**Re: Slim Chickens**  
**8240 Montgomery Blvd. NE**  
**Traffic Circulation Layout**  
Engineer's Stamp 07-5-2022 (G19-D004E)

Re: **SLIM CHICKEN-ALBUQUERQUE  
8240 MONTGOMERY BLVD.NE  
TRAFFIC CIRCULATION LAYOUT  
ENGINEER'S STAMP 05-18-2022 (G19-D004E)**

<div>ENGINEER'S SEAL</div> <div>RONALD R. BOHANNAN NEW MEXICO PROFESSIONAL ENGINEER 7868</div> <div>7-5-22</div> <div>RONALD R. BOHANNAN P.E. #7868</div>	SLIM CHICKEN 8240 MONTGOMERY BLVD NE	DRAWN BY pm
	SITE PLAN FOR BUILDING PERMIT	DATE 7-5-22
	TIERRA WEST, LLC 5571 MIDWAY PARK PL NE ALBUQUERQUE, NEW MEXICO 87109 (505) 858-3100 www.tierrawestllc.com	DRAWING 2021089-SP
		SHEET # SP-1
		JOB # 2021089

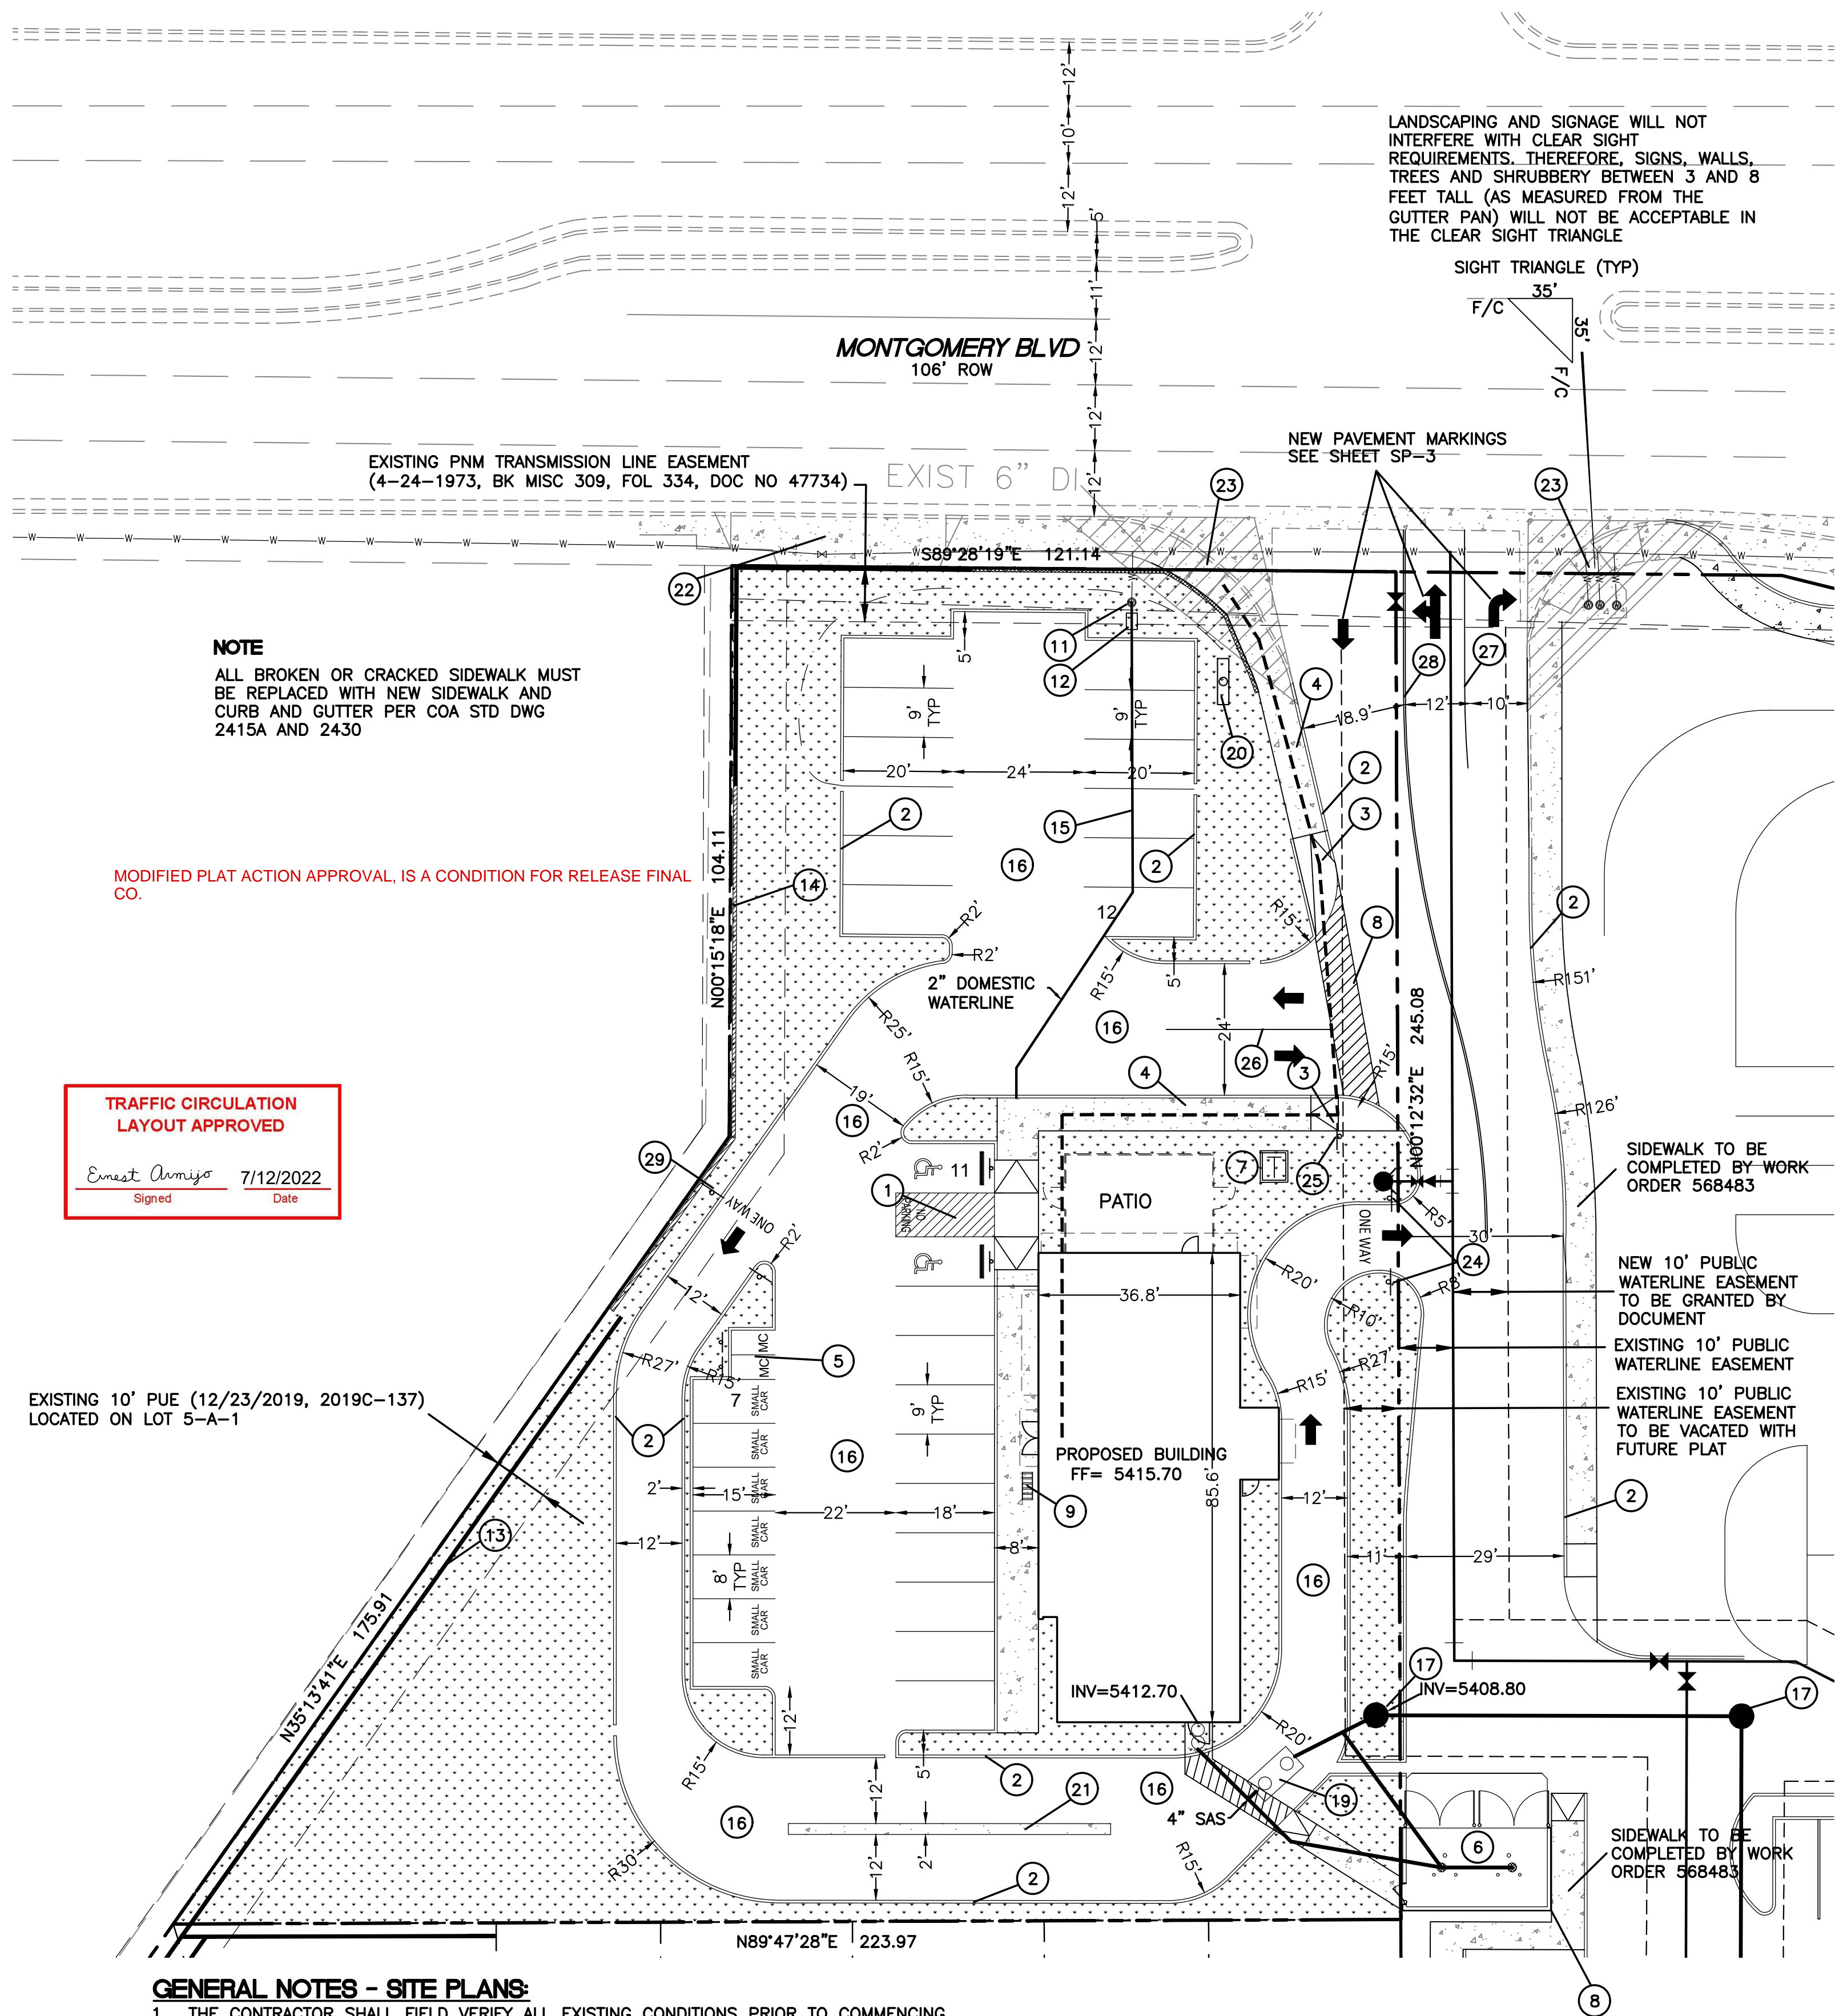
- Suggestion: redesign the main entrance per COA std dwg. 2426 to provide a 6' valley gutter with 1" invert. Replace the existing 4' valley gutter with 6' valley gutter to serve ADA across the entrance.

- The proposed drive aisle located mostly on tract 2. Please provide certified agreement with Tract 2 land owner.  
**The same owner for Tract 1 owns Tract 2 and is aware of the shift in the access. This area will be replatted with the easements adjusted once we receive approval for this TCL.**

- Plat for Wymont subdivision keynote 40: Private Rodway Easement should serve Tract 1-8. And on sheet 6 the location of driveway easement doesn't match the proposed drive aisle. The easement will need to encompass the proposed drive aisle shown on site plan. Please address this concern.

**We agree with this statement and plan to have the easement adjusted and recorded prior to the building opening for business.**
- Plat for Wymont subdivision keynote 41: Public sidewalk easement doesn't match site plan.

**This will also be updated on the replat.**
- Provide sidewalk connectivity to serve Tract 2.  
**The connectivity between Tract 1 and Tract 2 is via the sidewalk along Montgomery Blvd.**

- The main drive aisle will need striping for ingress/egress vehicles movement. Striping will be needed on the frontage segment of Slim Chicken.  
**We are showing new striping as requested.**

- Provide striping and arrows for the 24' proposed entrance.  
**We are showing new striping as requested.**

- Drive-thru lane: The exit lane has not throat depth for sight distance (oncoming traffic right vision with oncoming headlights and opposing traffic perception reaction). Please provide one storage length at exit to straighten vehicle for reaction of oncoming vehicles in both directions.

**This was reconfigured as we had discussed on the phone.**
- You will need the following: All one-way drives shall have "One Way" and "Do Not Enter" signage (both sides on exit) and pavement markings. Please show detail and location of posted signs and striping (include Stop Sign and sign face details).

**This information was added to the Site Plan and Detail Sheet.**
- The exit vehicular movement will be dedicated to a left turn movement ONLY. Provide a sign specifying left turn and no right turn out due to the tight radius which cannot accommodate the turn movement

6. CN 568483 be completed/accepted/approved by the COA  
**This is understood.**
7. Proposed Dumpster: Provide a letter from adjacent property owner stating that it is okay ok to have Dumpster located outside the lot of proposed development.

**As we are not modifying the entrance itself and the existing valley gutter is in good condition we believe it best to leave it as is.**

**With the new drive thru configuration we believe this can be a full exit.**

**The same owner owns Tract 2. We can provide an Agreement prior to CO if that is acceptable.**
8. Traffic Studies: See the Traffic Impact Study (TIS) thresholds. In general, a minimum combination of 100 vehicles entering and exiting in the peak hour warrants a Traffic Impact Study. Visit with Traffic Engineer for determination, and fill out a TIS Form that states whether one is warranted. In some cases, a trip generation may be requested for determination (Contact Matt Grush: mgrush@cabq.gov). Please contact Matt Grush to fill TIS form.
